Re: Broadwater Energy LLC, Docket No. CP06-54-000
Broadwater Pipeline LLC, Docket Nos. CP06-55-000 & CP06-56-000

Enclosed for filing in the referenced proceedings is a copy of the responses of Broadwater Energy LLC and Broadwater Pipeline LLC to certain information requests of the New York State Department of State regarding alternatives (NYSDOS Nos. A-1 – A-9).

NYSDOS A-1

Broadwater LNG Project
New York Department of State F-2006-0345
Atlantic Alternatives Information Request
Page 3 of 17

Figure N-1 – NY/NJ Traffic Separation Scheme

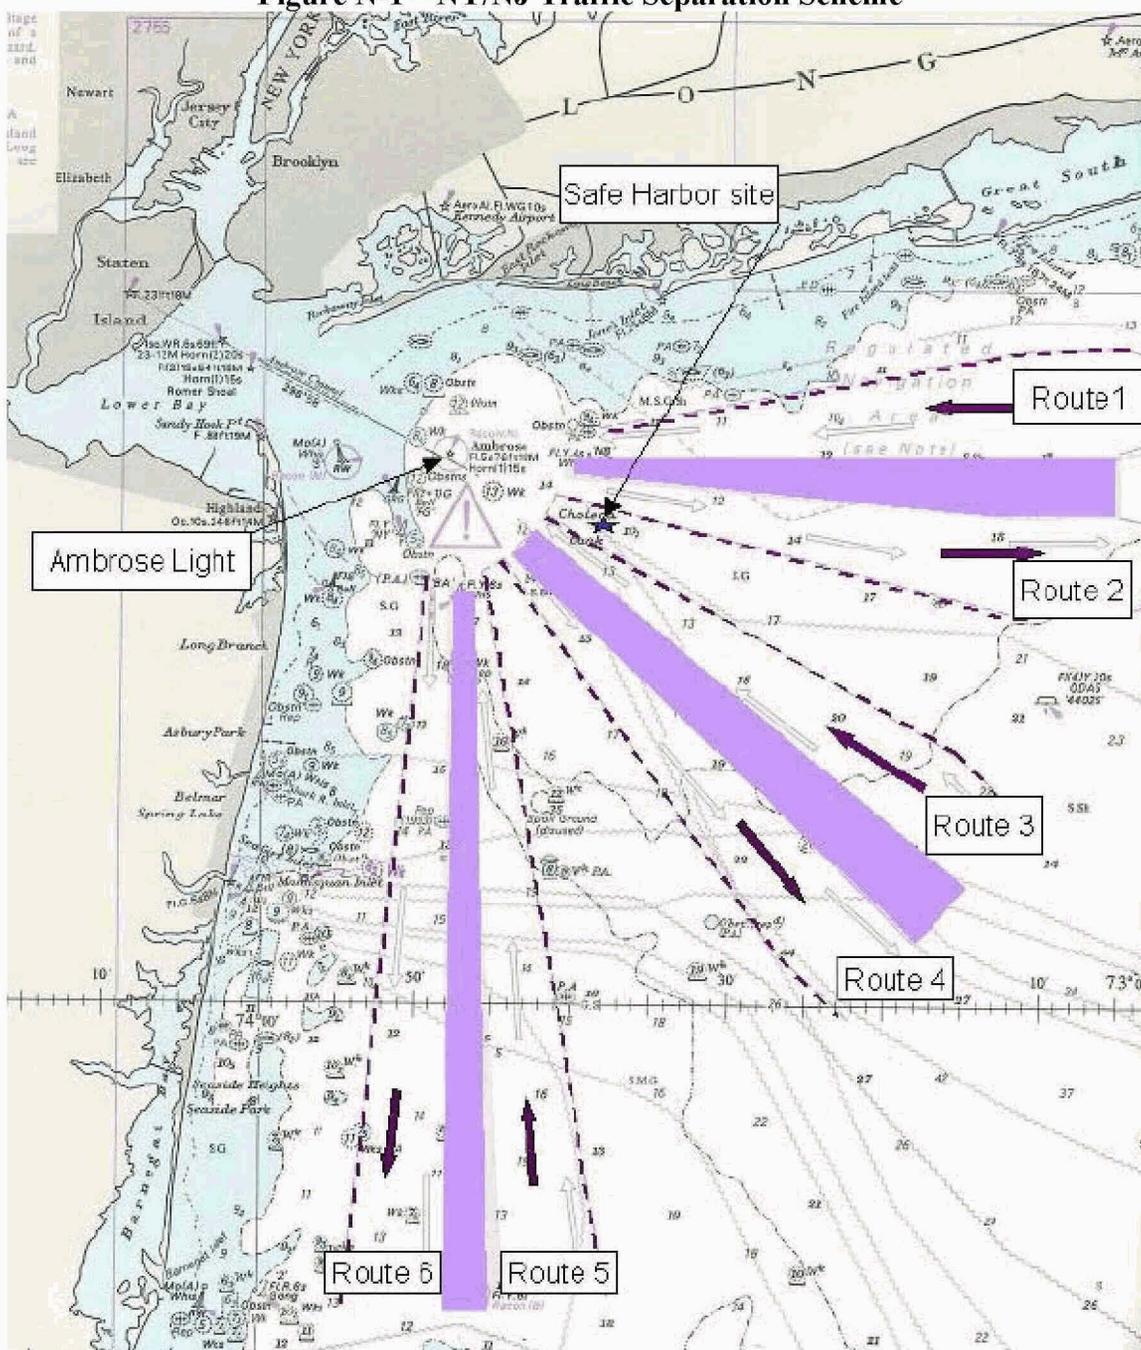
"The ships arriving and departing from New York will be using one of the six numbered traffic lanes identified in Figure N-1. Data on ship traffic numbers in the area was sought from the U.S. Department of Transportation Maritime Administration, who advise 4,902 port calls, or 9,804 ship movements, of vessels greater than 10,000 tons deadweight; their source is reported as Lloyds Marine Intelligence Unit (LMIU). New York pilots advise that the approximate annual number of ship movements is about 11,000 to 12,000 per year.

Figure 2- NYDOS Chart Indicating Proposed Alternative Locations

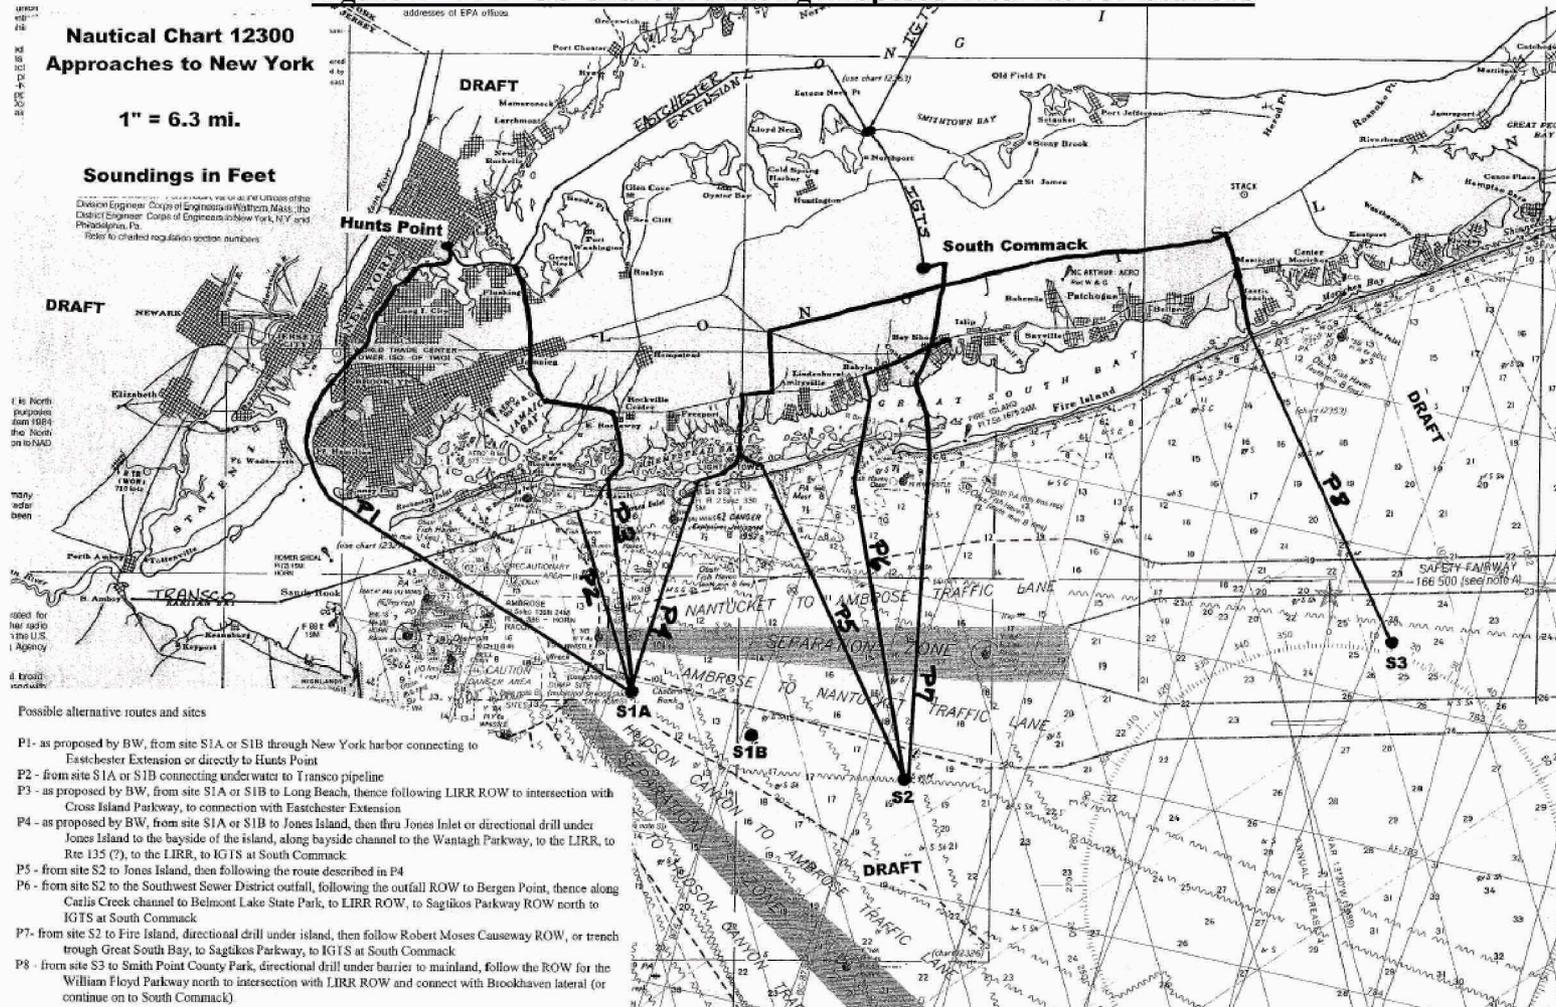
Refer to Figure 2, which was provided to Broadwater by NYSDOS.

Figure 3 Areas to be Avoided

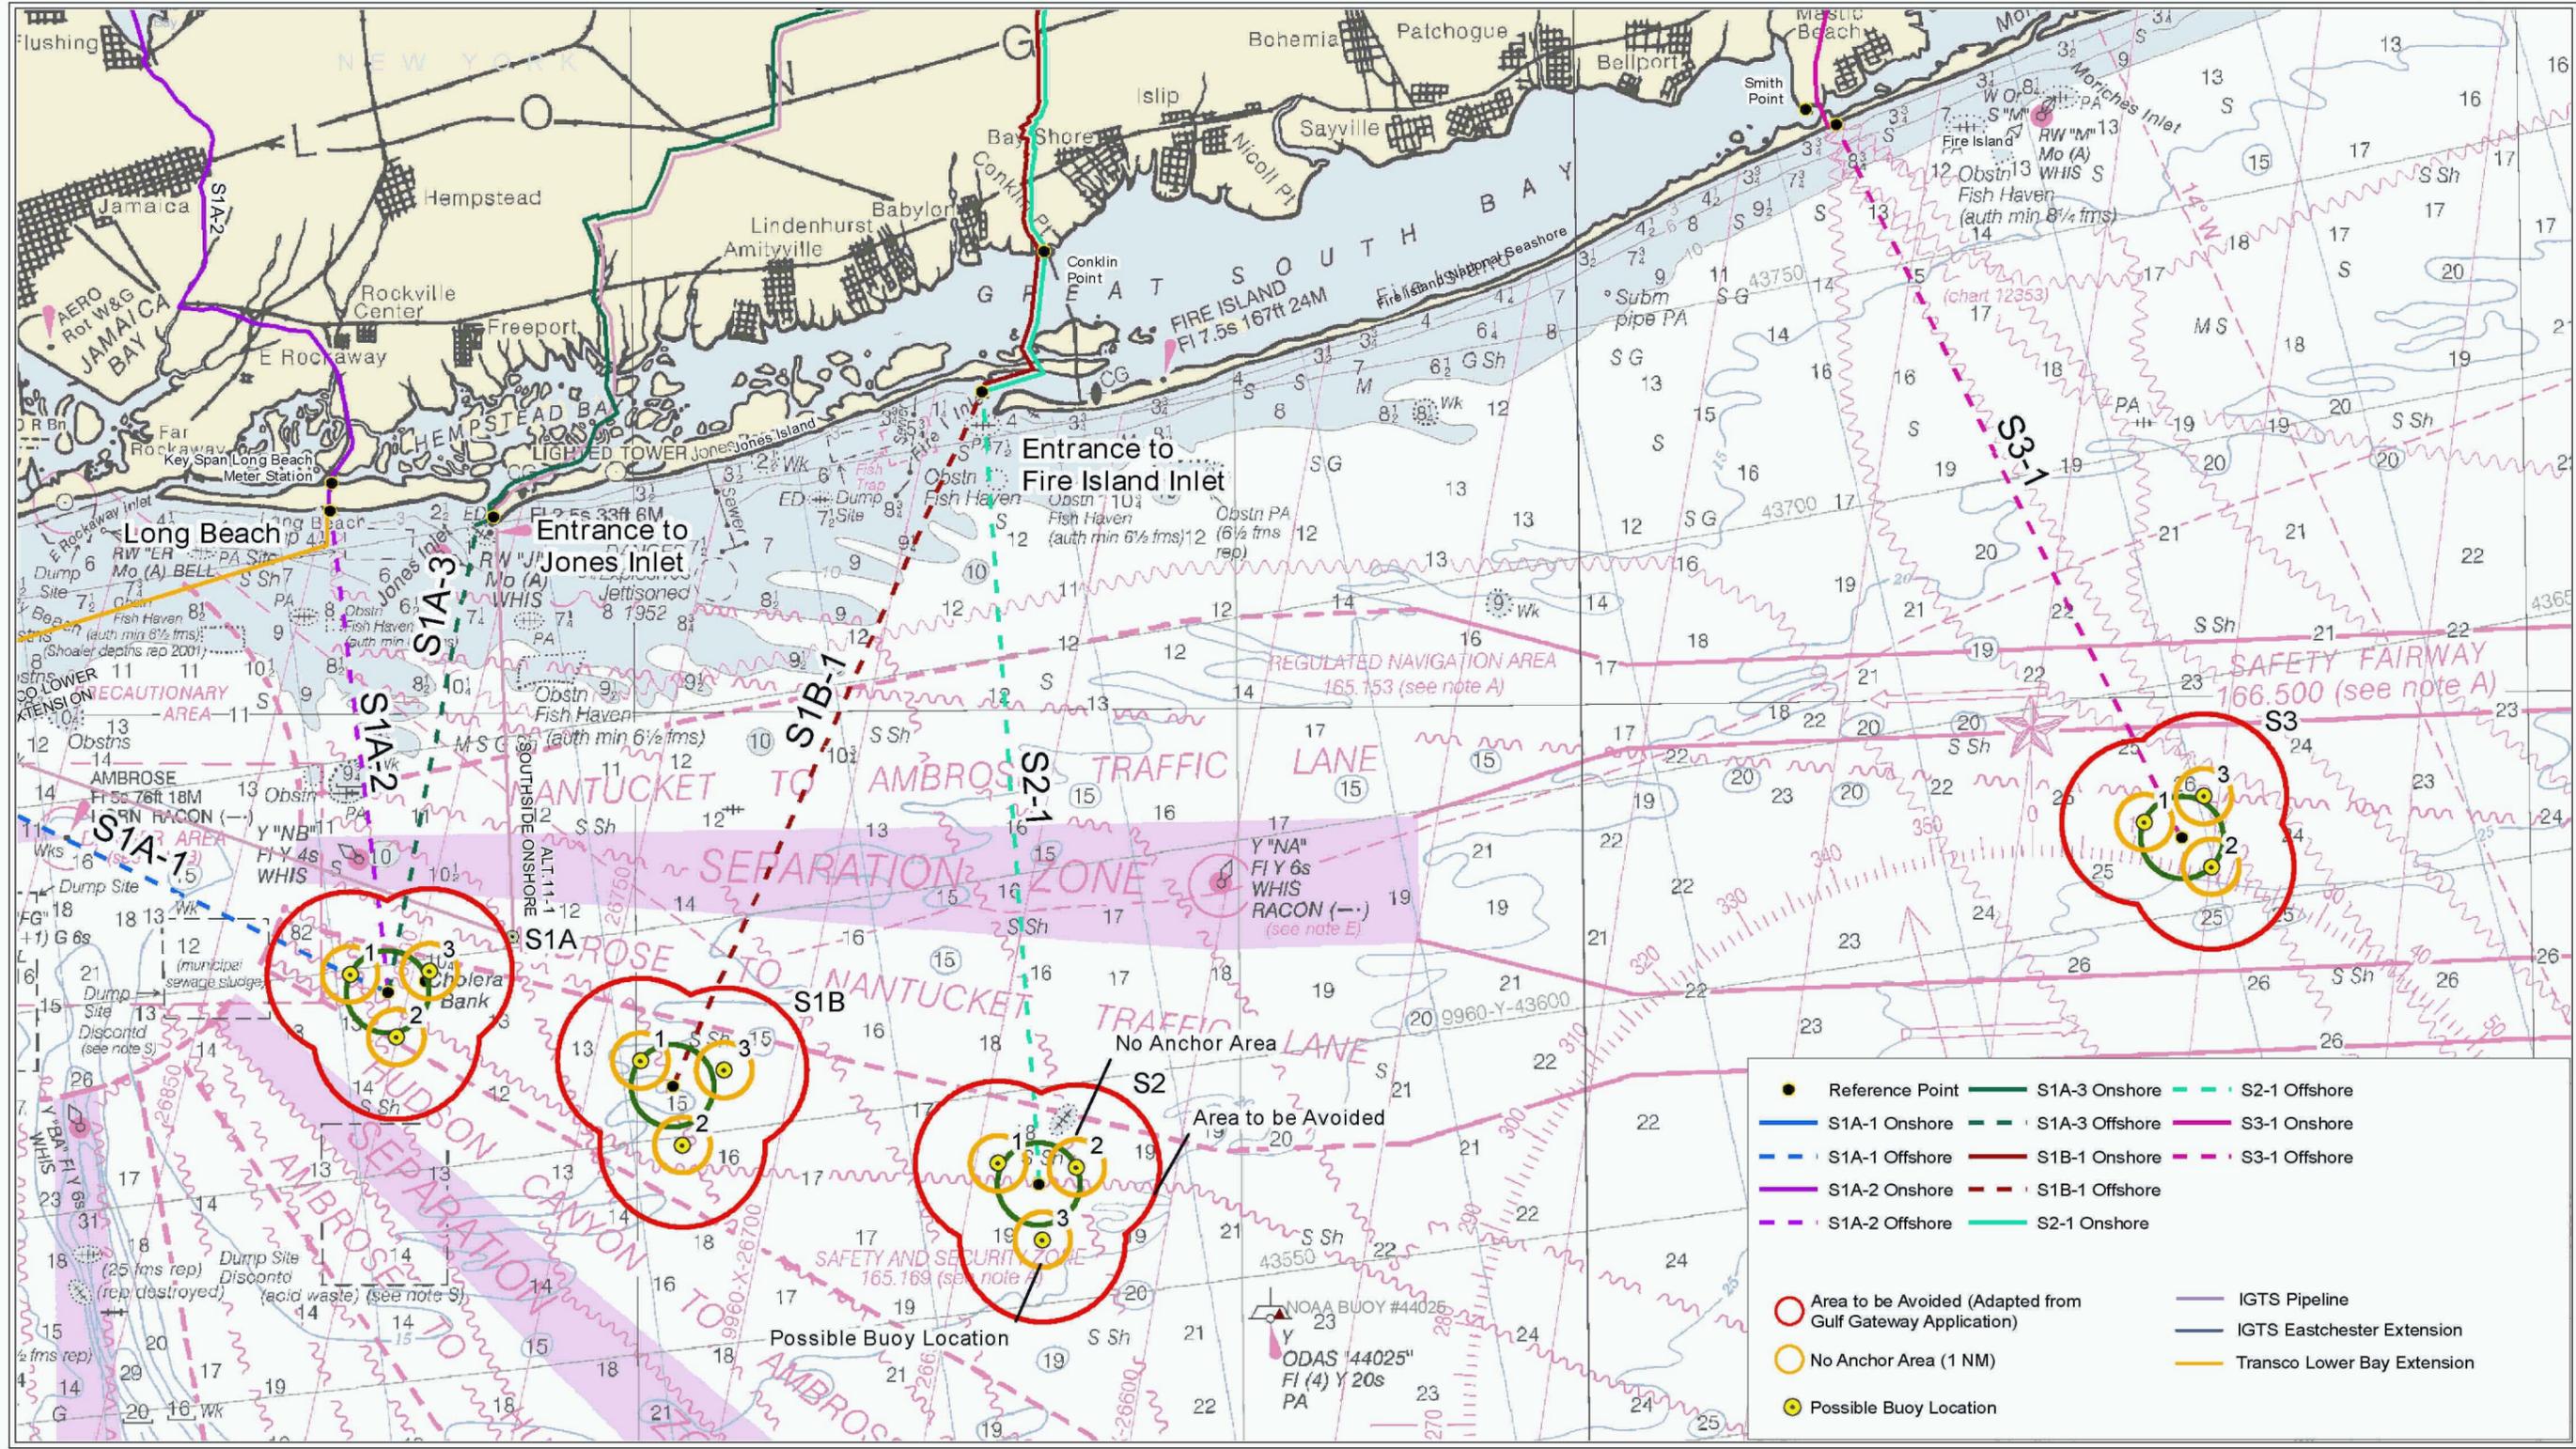
Locations S1A, S1B, S2 and S3 are shown on Figure 3 (attached), relative to the Traffic Separation Scheme (TSS) in the area. Locations S1A, S1B and S2 are located within a sector separating the inbound and outbound lanes of the TSS located off Ambrose Light.

If the DOS-proposed positions (S1A, S1B, S2 and S3) were utilized and 3 STL buoys were located around these positions to minimize the impact to the surrounding TSS, either the Safety Zone, the No Anchoring Area or the Area to be Avoided would (if using the same criteria as that identified above for the only operational U.S. offshore deepwater port [the Gulf Gateway Deepwater port]), in three of four cases shown in Figure 3, would encroach significantly upon the TSS lane. The only location for which this would not be the case is the S3 location, which encroaches to a lesser extent. However, other issues with the S3 location, relating to the additional environmental impact associated with the connection pipeline, potential shoreline impacts and the unsuitable metocean conditions, are detailed in Broadwater’s FERC filing of June 20, 2007.

Figure 3
Port Dolphin Subsea Components

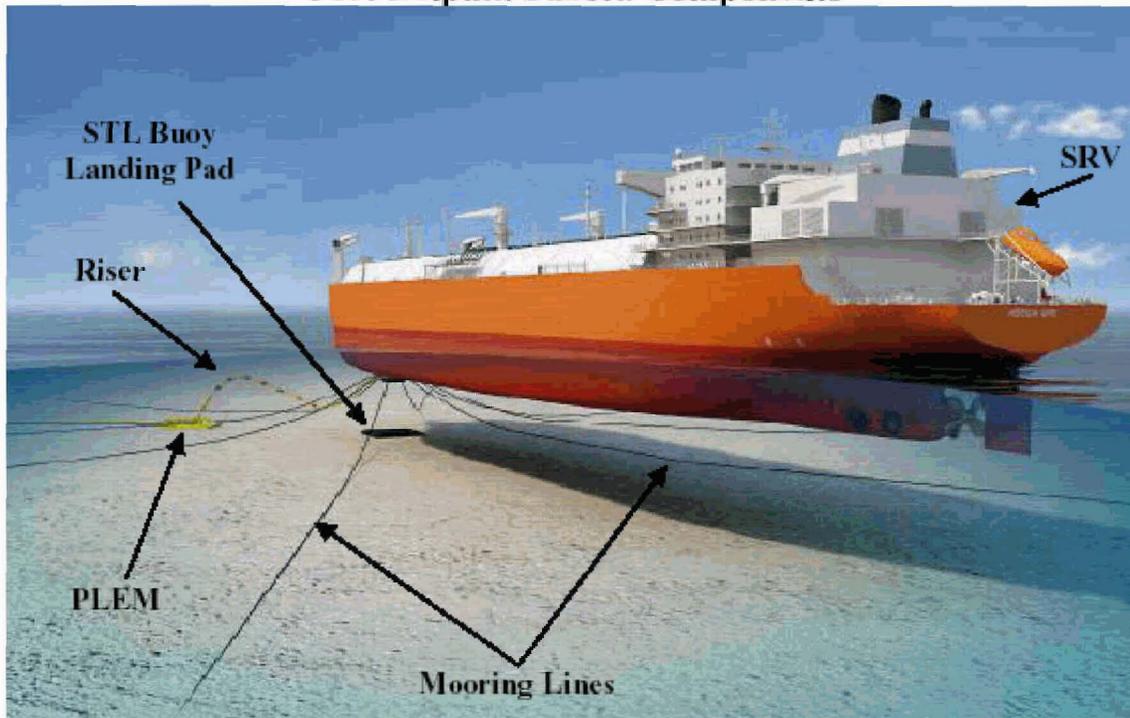
Port Dolphin have proposed that, due to the shallow depth of water at the location, the STL buoy, when released from the SRV sits upon a STL buoy landing pad. This will result in some environmental impact to the sea bottom, which the applicant must define. See Figure 3.

FIGURE 1
Flowchart of Sloshing Analysis and Strength Assessment
of LNG Containment System

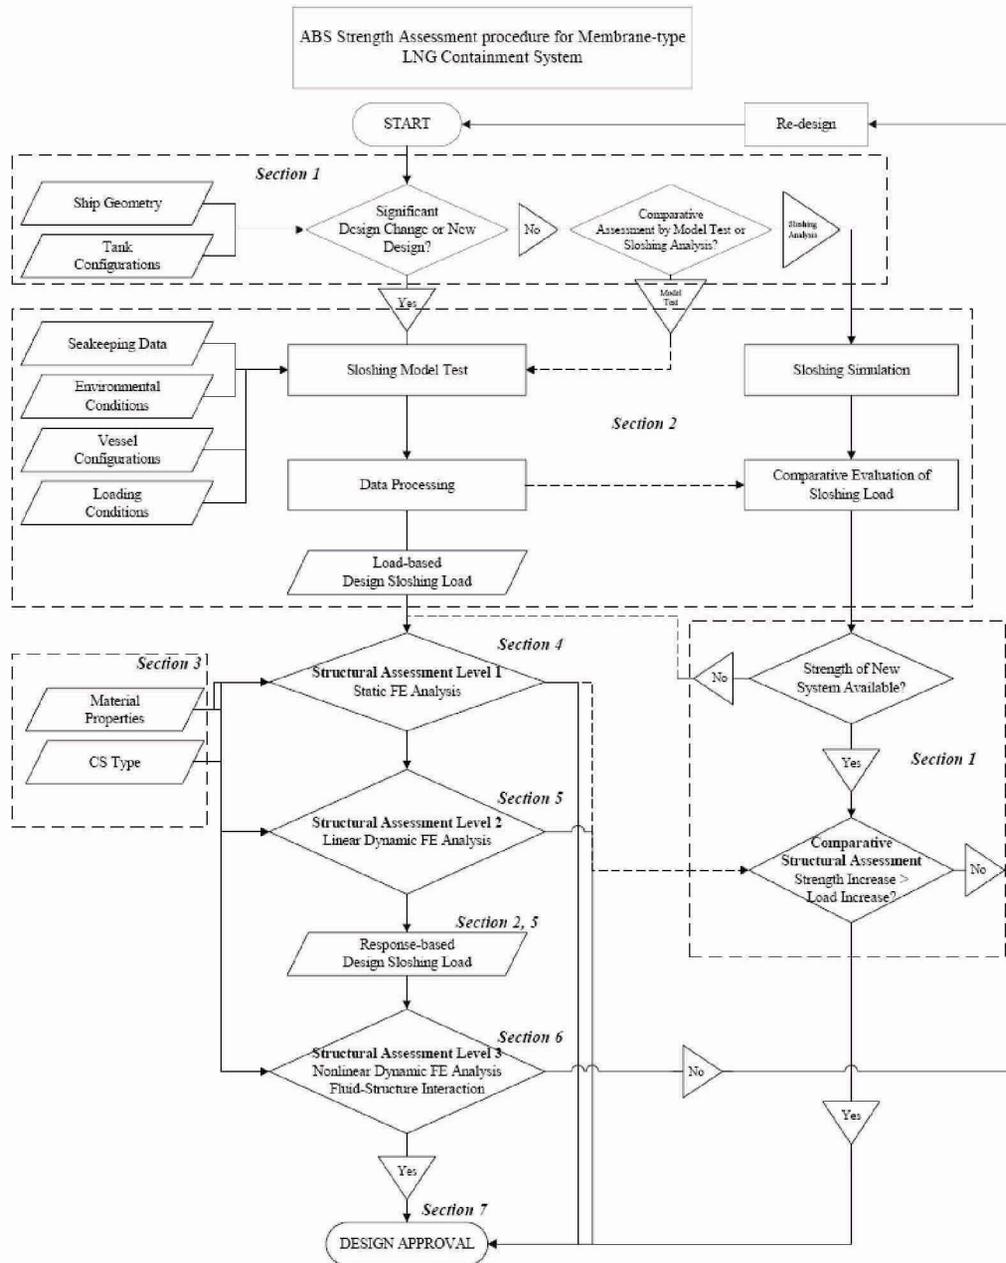
Broadwater has stated that locating a facility, either SRV or FSRU in the Atlantic Ocean would expose the project to a more energetic ocean environment which could create a storage containment issue known as "sloshing" which could cause structural damage to the storage membrane. Given the SRV projects that are now in various stages of development, the industry appears confident with the ability to minimize sloshing effects onboard SRVs. What data or documentation can Broadwater provide that demonstrates that operational procedures and/or engineering solutions could not address this issue with FSRU's and SRV's?

The evaluation of loads associated with sloshing is a complex process requiring model testing and analysis. Figure 1, taken from the American Bureau of Shipping's (ABS's) *Guidance Notes of Strength Assessment of Membrane-Type LNG Containment Systems*, April 2006 (page 7) provides an illustration of the evaluation process.¹ There are a number of instances where sloshing loads have damaged LNG membrane containment systems.
